project: **A3 DRAWING** NOTED SCALES RELATE TO A3 DRAWINGS  
**PROPOSED SUBDIVISION**

location: 9 BALLARD ST, LAKES CREEK, QLD , 4701

Letter Information Request Response Technical Memorandum – 23076LETIRRTM01

**Information Request Response Technical Memorandum  
Two Lot Subdivision (D/43-2023)  
9 Ballard Street, Lakes Creek**

Project Number  
**SK03[1]**  
Date  
**23076**  
**30/11/2023**  
**LOT 2 DRIVEWAY SIGHT DISTANCE PLAN**

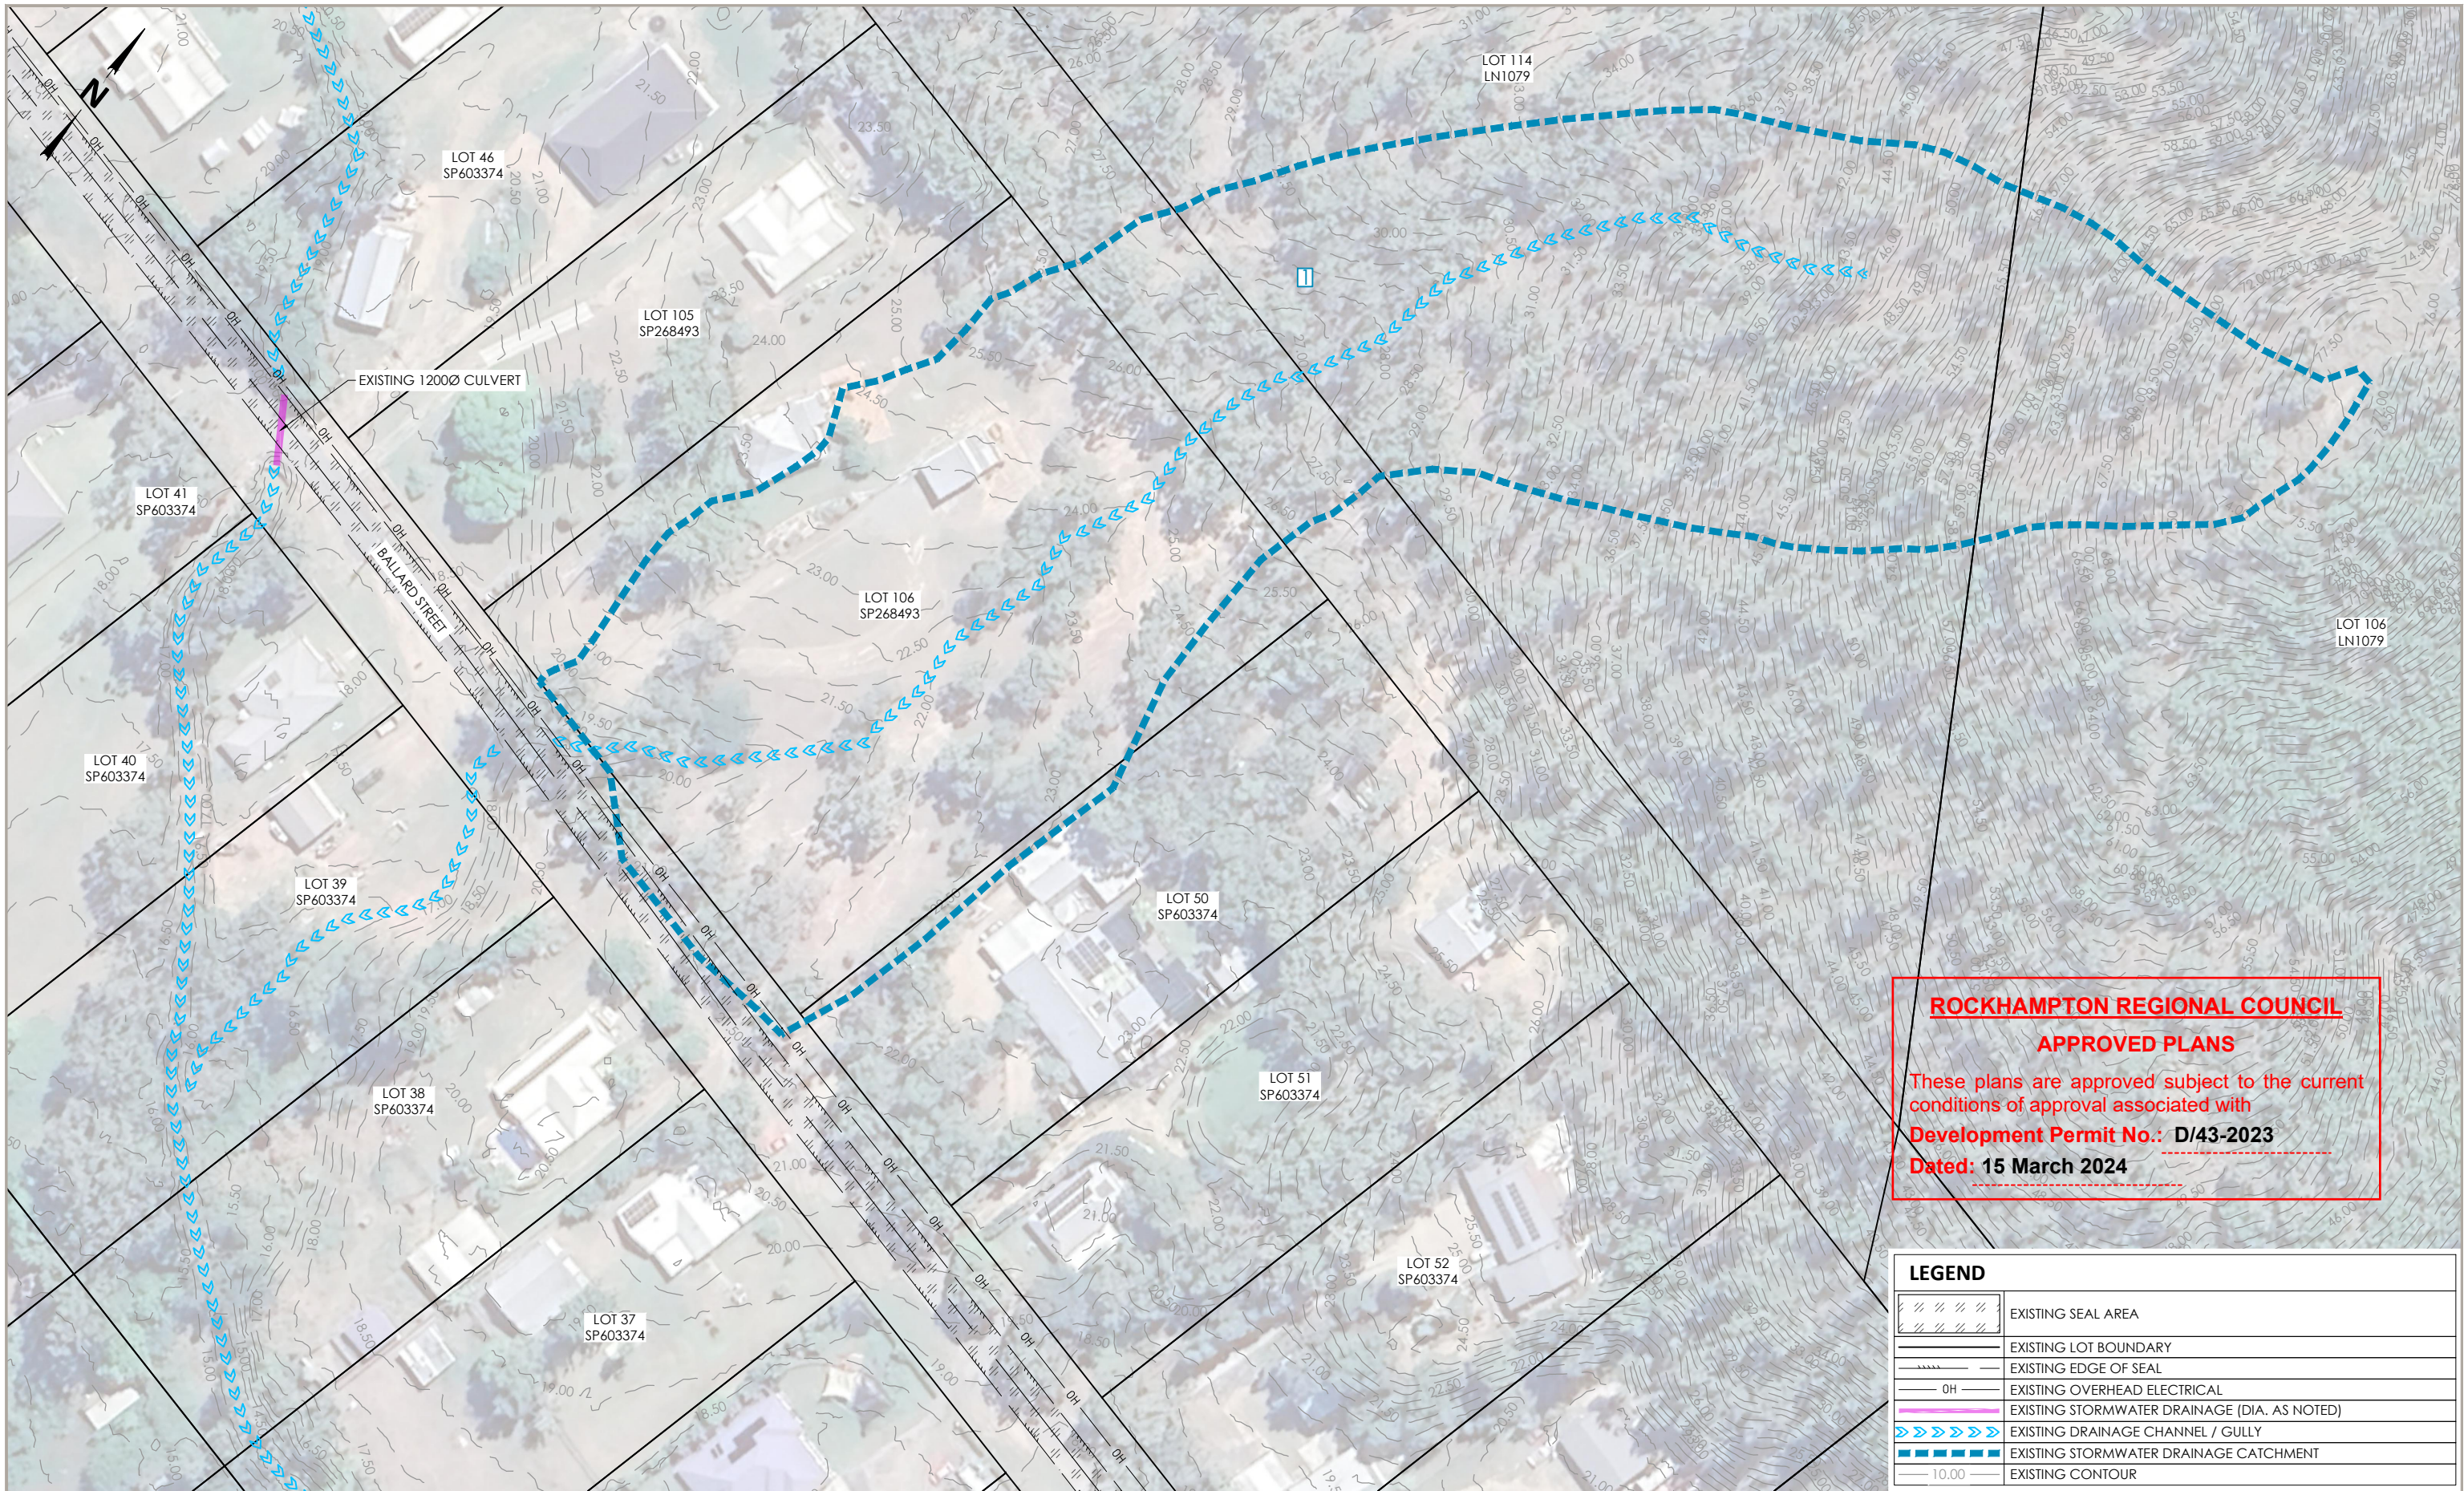
**Item. 1.2** Provide an engineering assessment to demonstrate that any future development on proposed lot 2, complies with the Capricorn Municipal Development Guidelines requirements for Driveways, particularly regarding sight distance in accordance with Austroads recommendations.

Using an approximated road centreline for Ballard Street based on LiDAR data, the sight distance requirements were overlaid (Northern and Southern approaches) to determine a suitable location for the new Lot 2 driveway. This location has been determined to be within 25m and 30m from the lot 2 southern boundary.

Civil engineering drawing 23076-SK03 (included in Attachment 3) shows a section of the northern and southern approaches with sightlines and object heights, as well as dimensions to locate the driveway. It is our recommendation that the centreline for the proposed Lot 2 driveway be located 27.5m north of the Lot 2 southern boundary. An indicative layout of the proposed rural driveway has been shown. This indicative driveway layout is subject to change in further detailed design stages of the project.

**SK01[1]**      Project Number  
**23076**      Date  
**30/11/2023**  
**EXISTING SITE AND CATCHMENT PLAN**

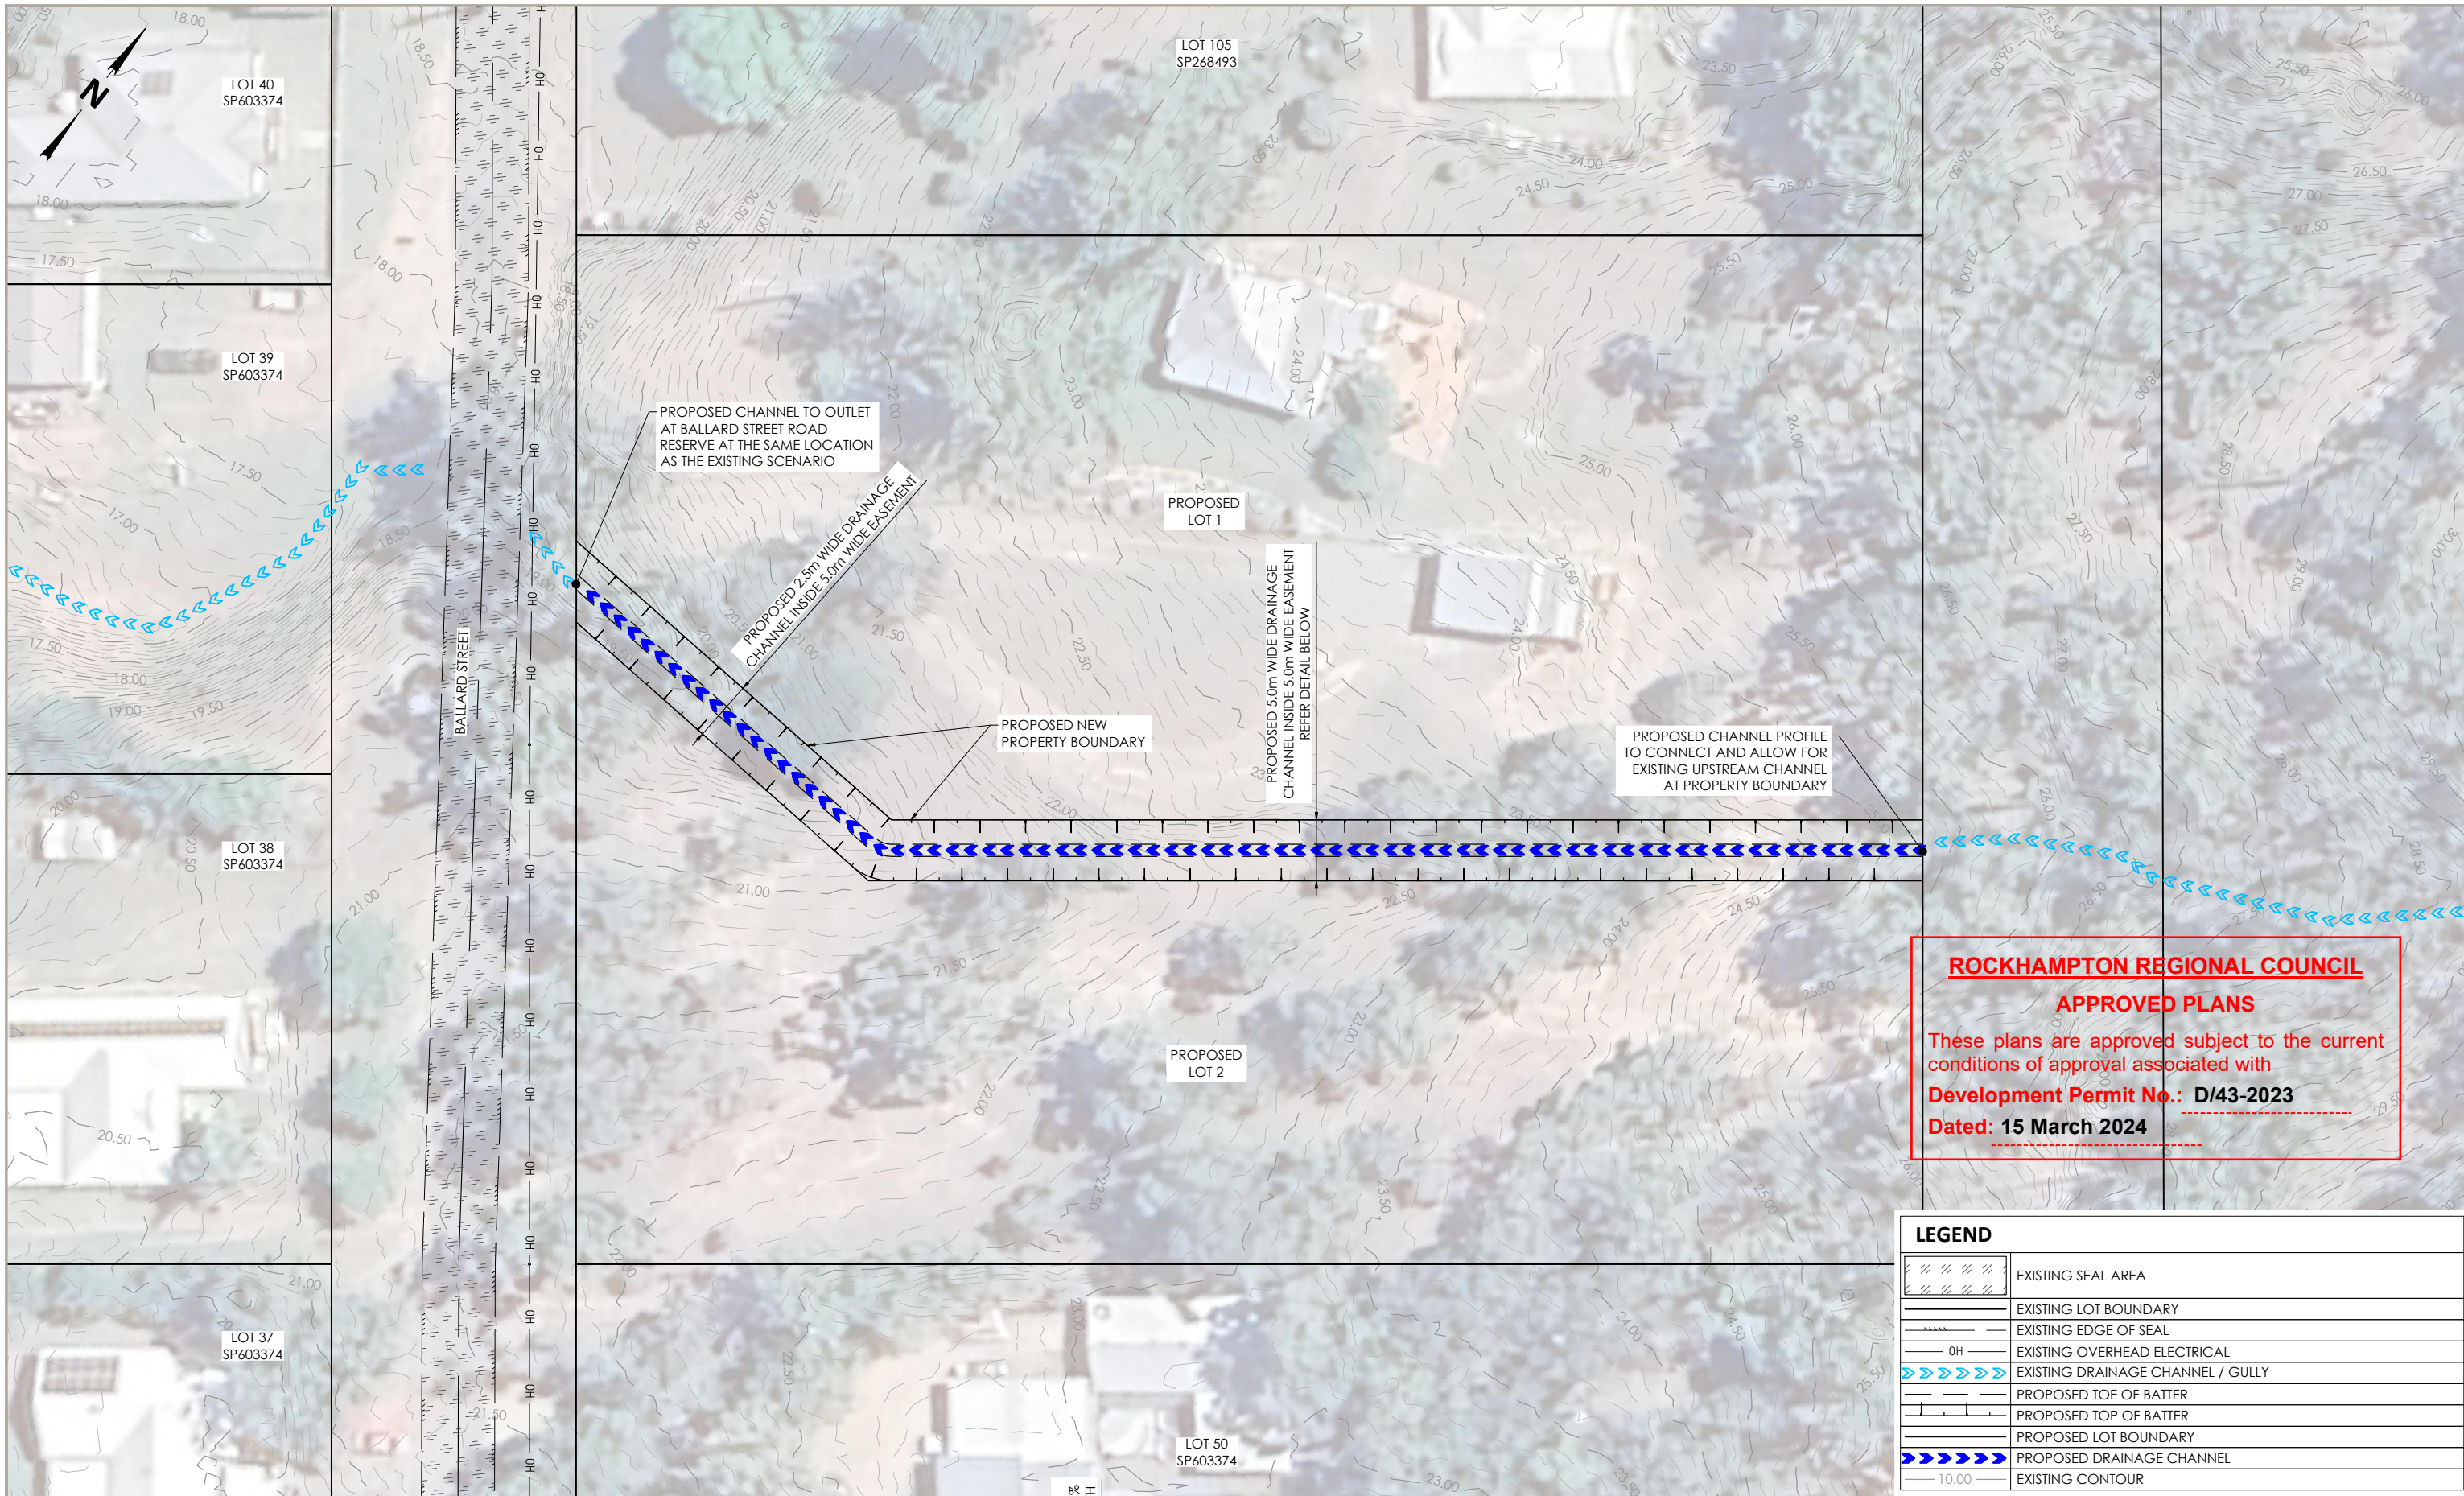
**Item 1.1 Provide and overland flow path assessment report for the subject land. Prepared and certified by a Registered Professional Engineer of Queensland, that as a minimum includes:**

The existing site topography generally falls from the east, north-east towards the south-west Ballard Street frontage where the average surface grades are approximately 5%. There is an existing gully that meanders roughly through the centre of the lot, which discharges to the Ballard Street road reserve at the base of a rise in the road which is approximately 2.0m high. There is currently no stormwater infrastructure in the vicinity of the gully discharge location onto Ballard Street, where the runoff from the gully crosses the Ballard Street road reserve before ultimately connecting to another overland flow path forming part of a larger creek system. There is an existing 1200mm diameter pipe culvert structure under Ballard Street approximately 70m north taking runoff from the larger creek.

Upstream of the site, the existing gully continues towards the north-east with longitudinal grades varying from approximately 5% at the rear of the site to near 1 in 2 (50%) at the top of the catchment where this part of the contributing catchment is considered to be vegetated bushland. The existing catchment extent and approximate gully lines can be seen on the civil engineering drawing 23076-SK01 attached to this letter (Attachment 1).
